Midway City Council
5 October 2021
Regular Meeting

Mill Canyon Farms Subdivision /
Preliminary Approval

CITY COUNCIL MEETING STAFF REPORT

Subject: Mill Canyon Farms – Preliminary Review

LAW
 MILL CANYON FARMS
 PRELIMINARY SITE PLAN

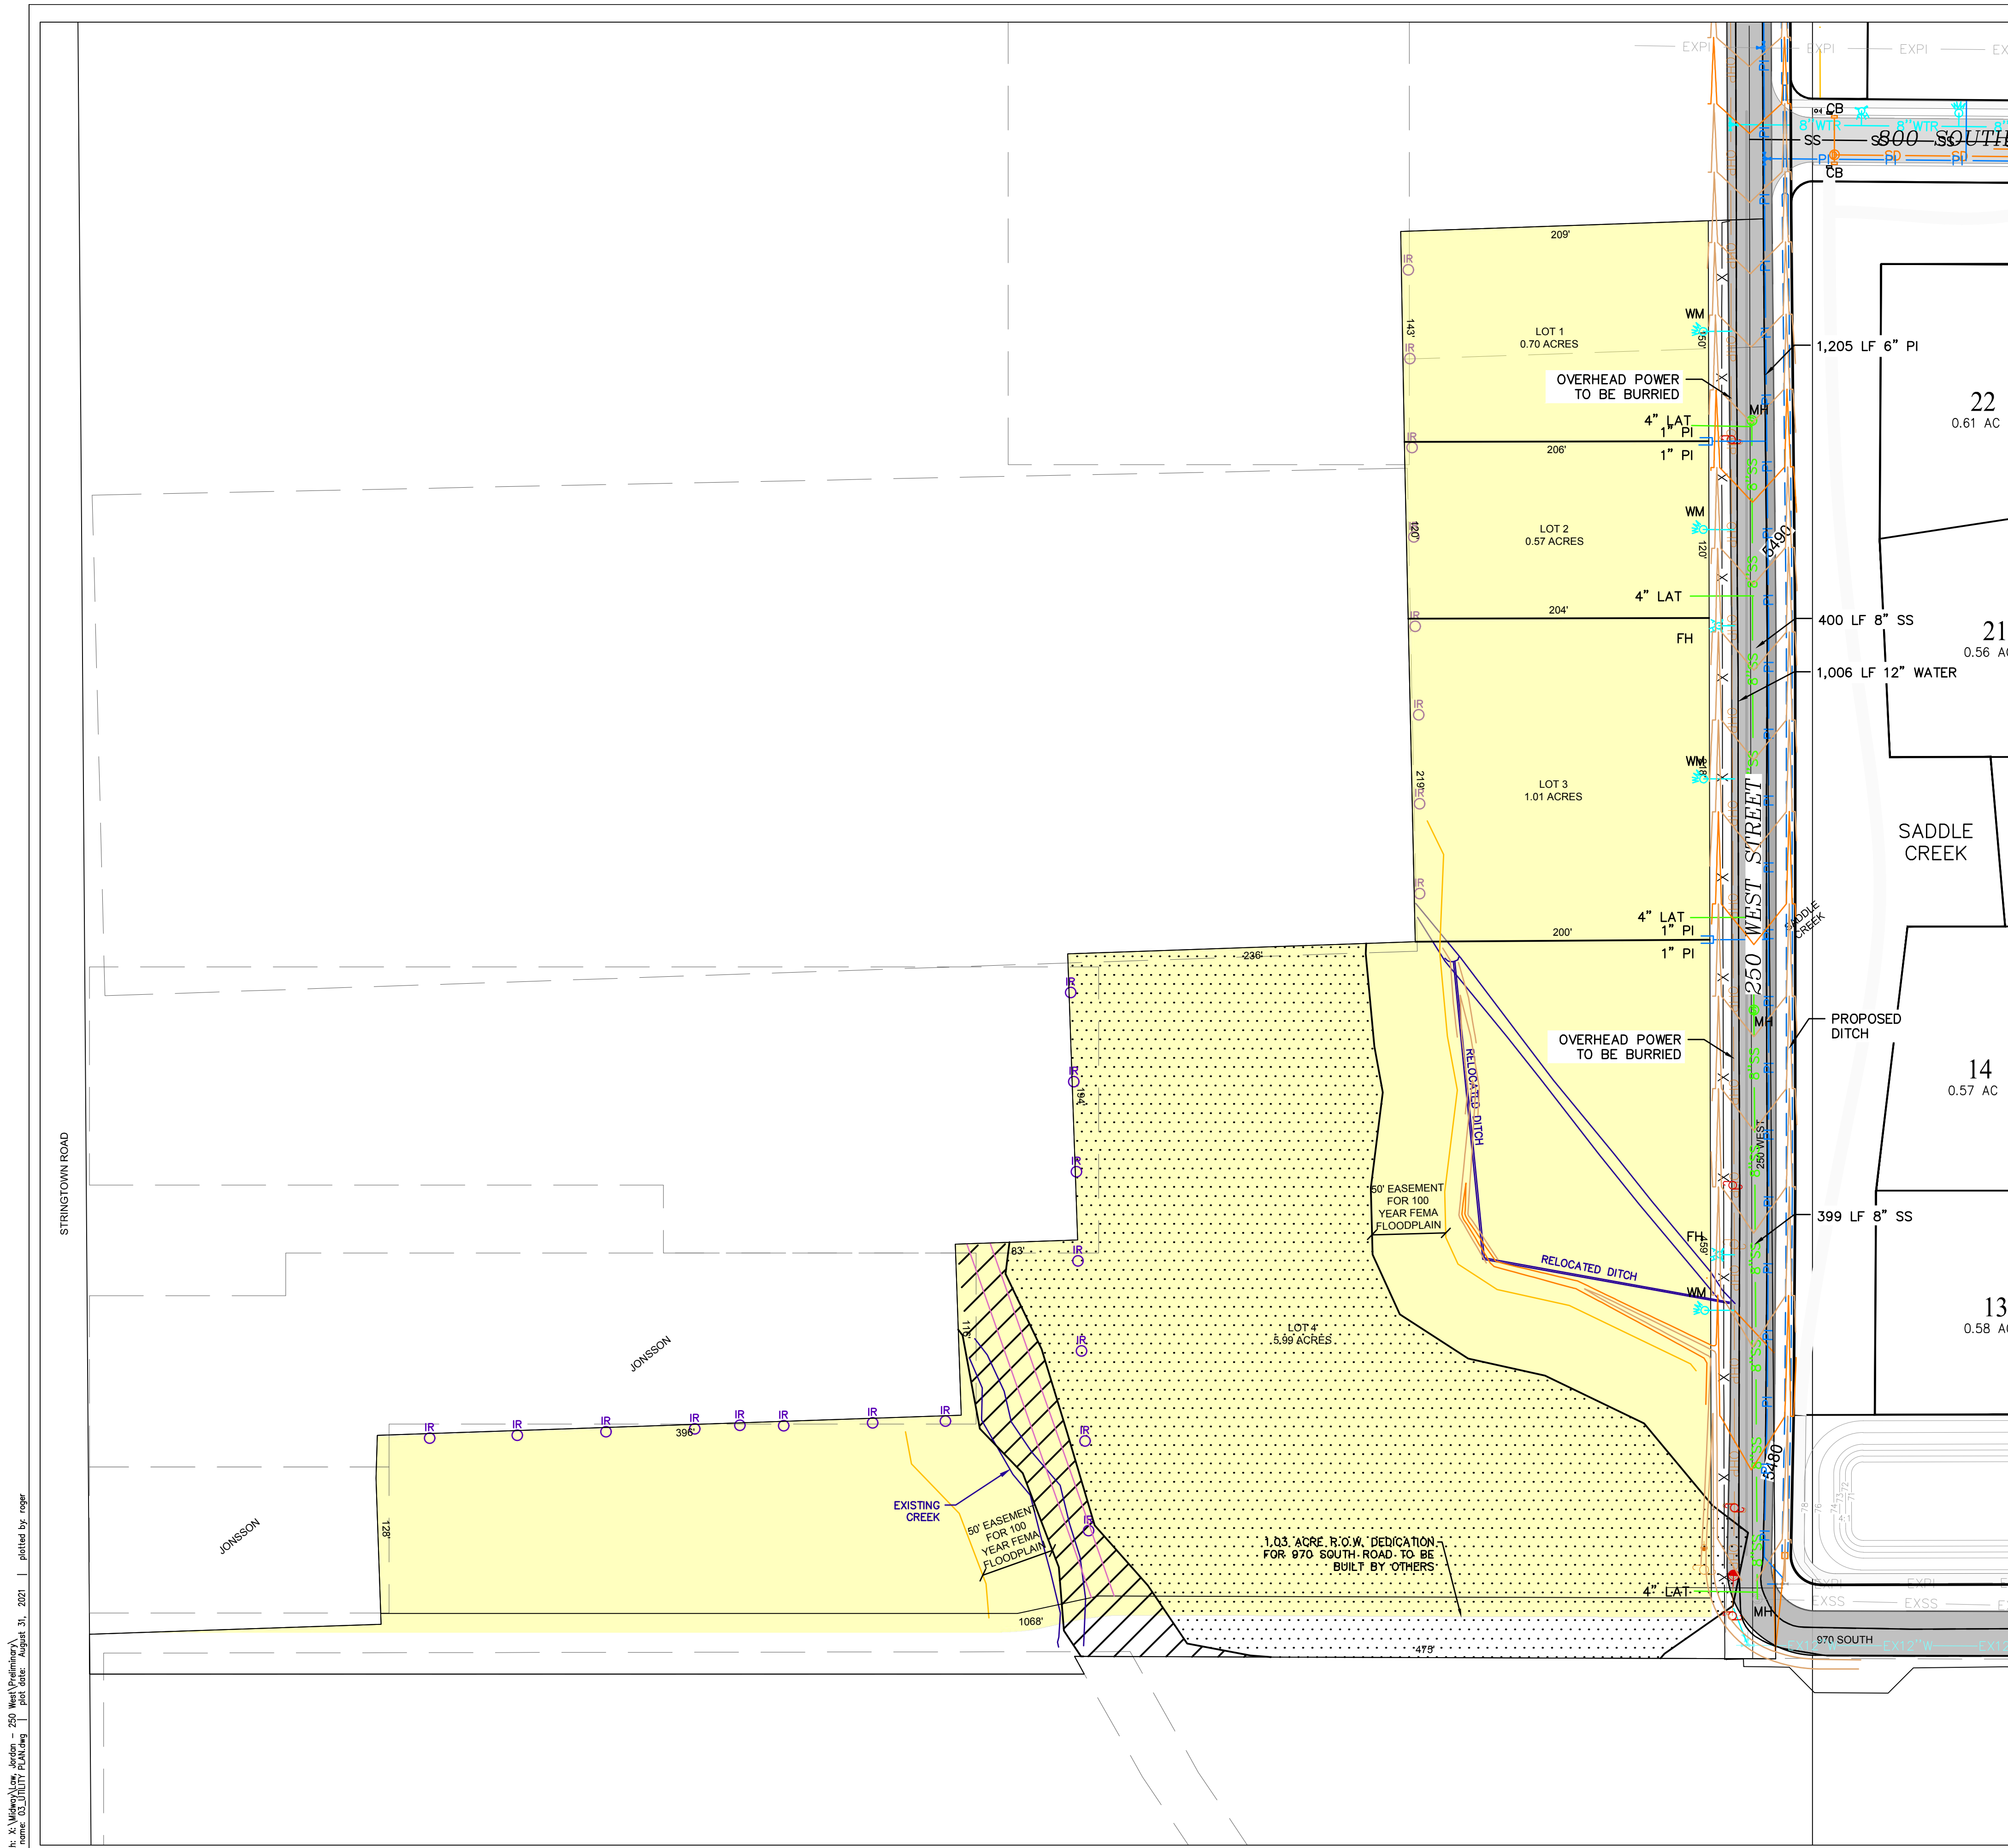
- The west side of 250 west will be rebuilt and widened to a half width of 15 to match the east side done as part of Saddle Creek Subdivision.
- The development will dedicate R.O.W for a future road to extend 970 South from 250 West to Stringtown Road.

- No trails are shown to be constructed within the development, the development will need to dedicate 15' R.O.W for a future trail along future 970 South and will need to dedicate 20' R.O.W for a future trail along Snake Creek.

- The proposed lot 4 in the subdivision is within a designated FEMA flood plain. A 50' setbacks shall be maintained around all FEMA flood Zones.

250 WEST ROAD IMPROVEMENTS

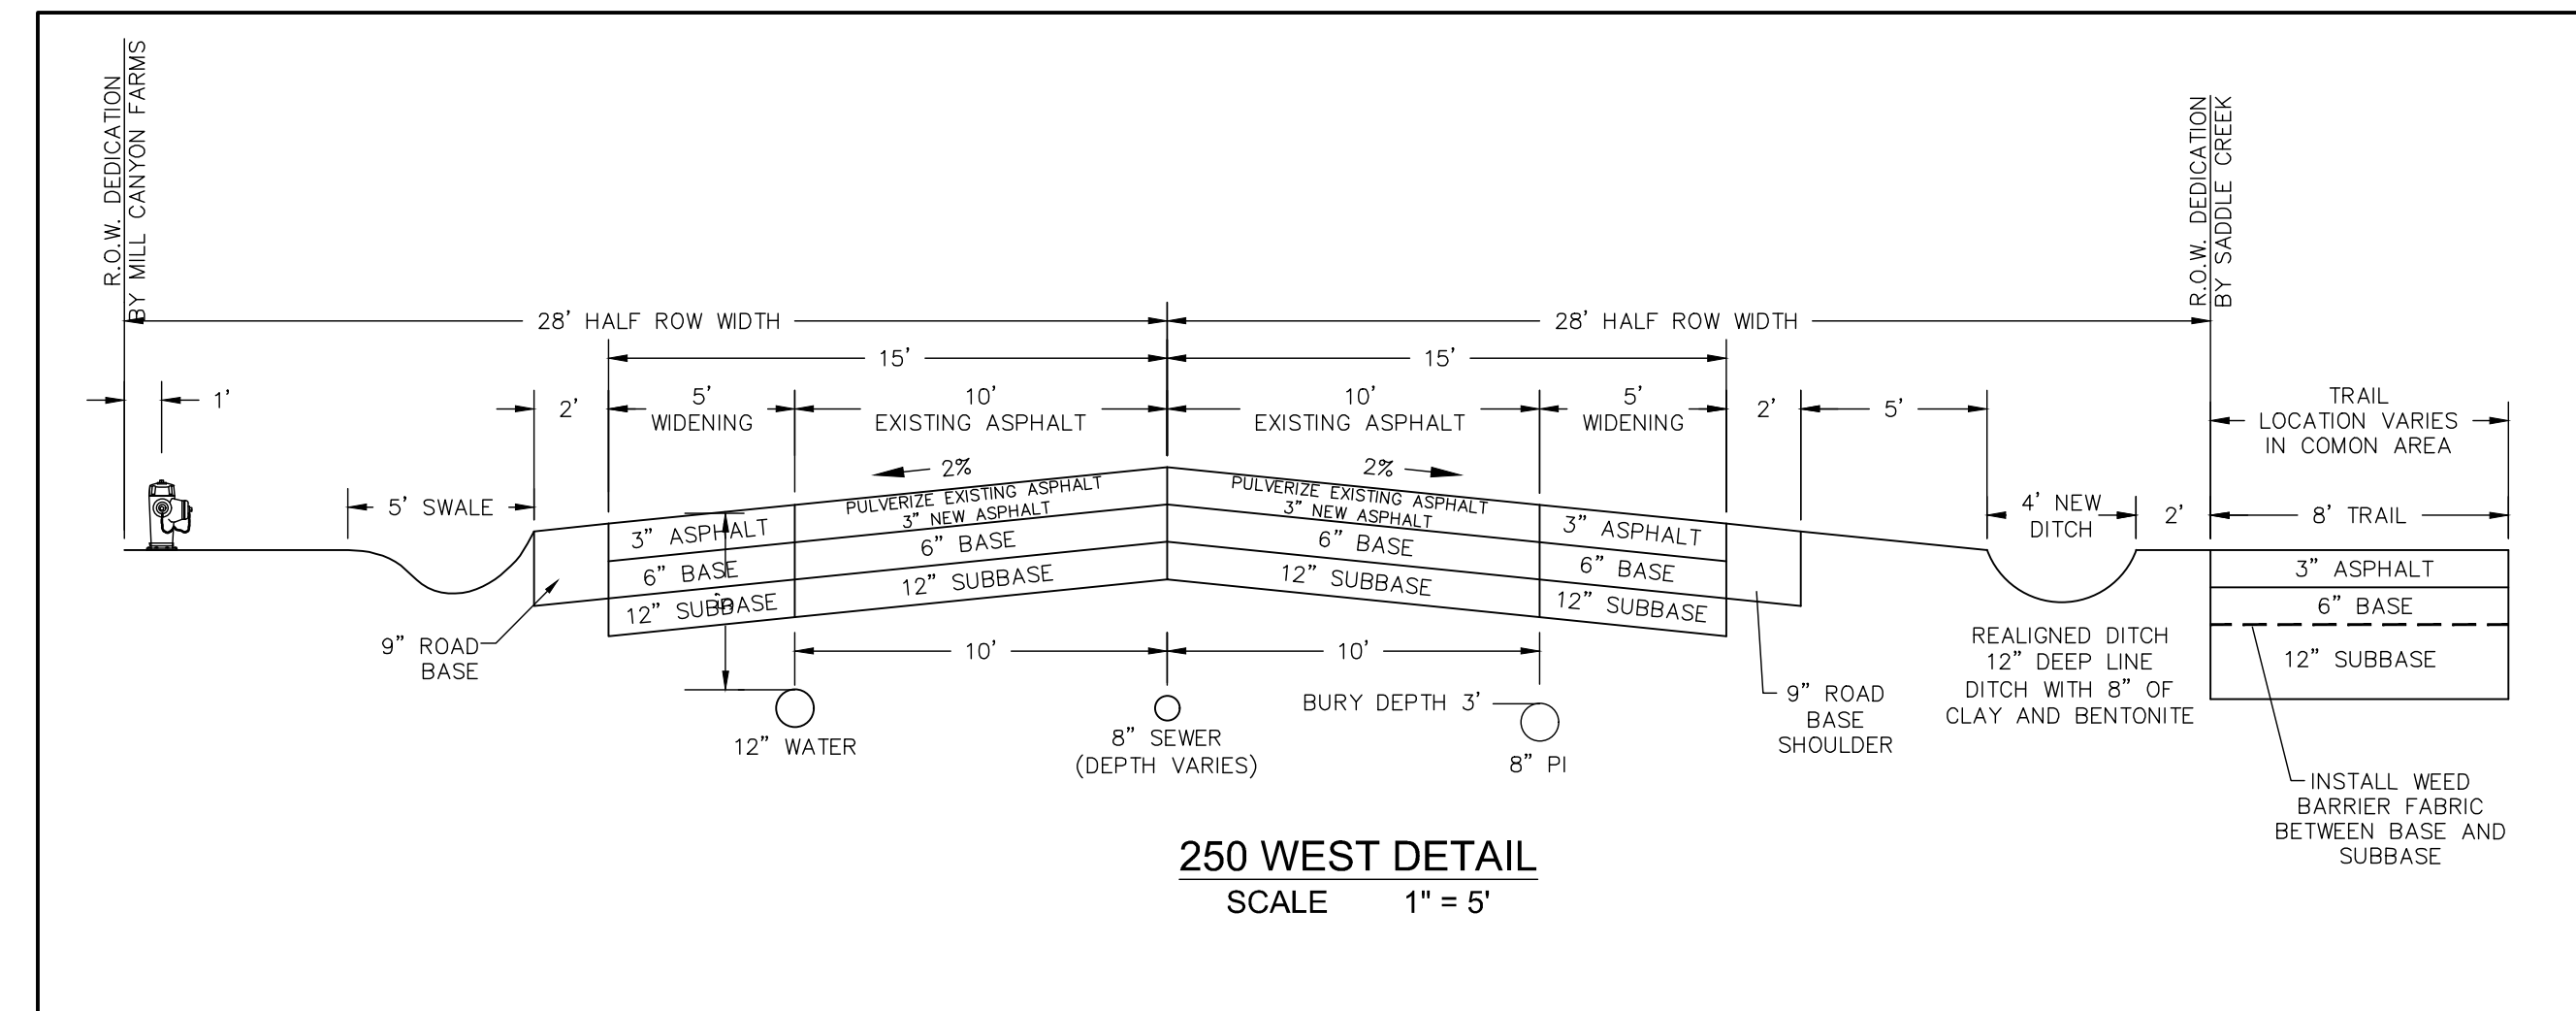
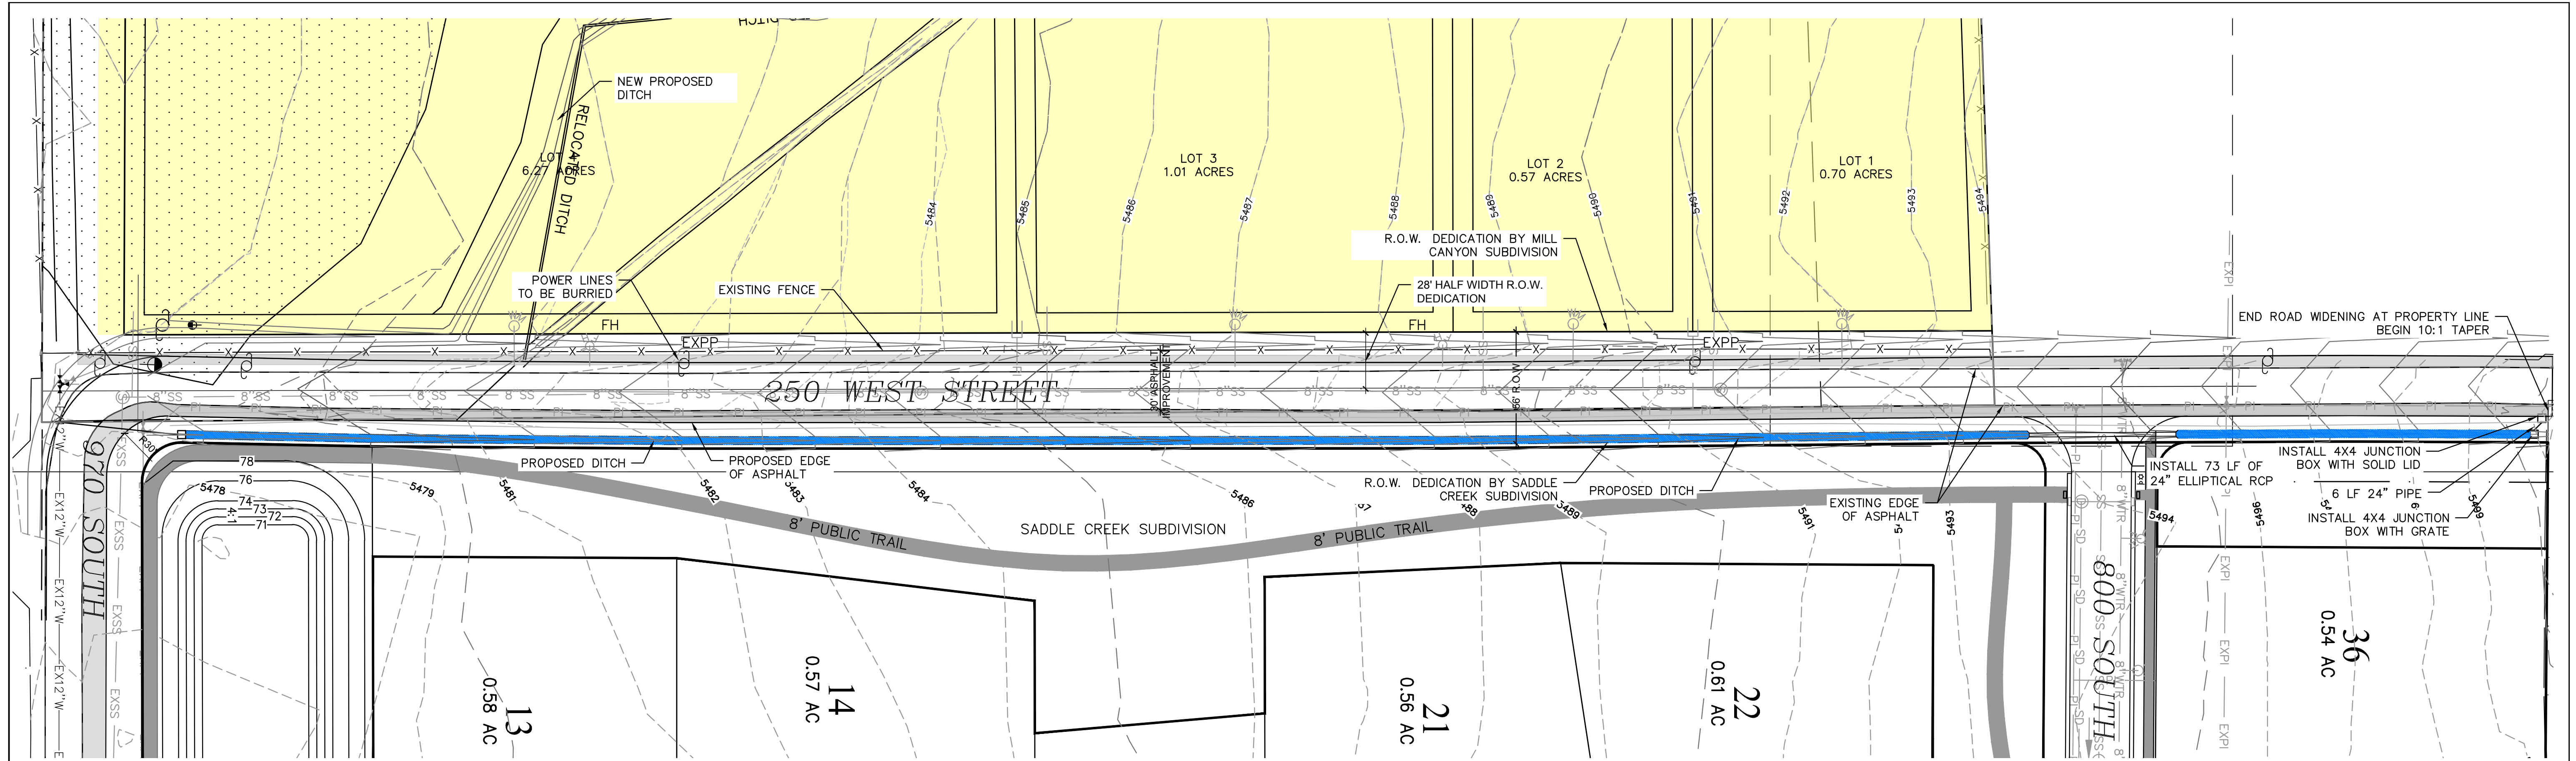
- The proposed swale along the west side of 250 West will accommodate any storm drainage from the widening of 250 West and this development.
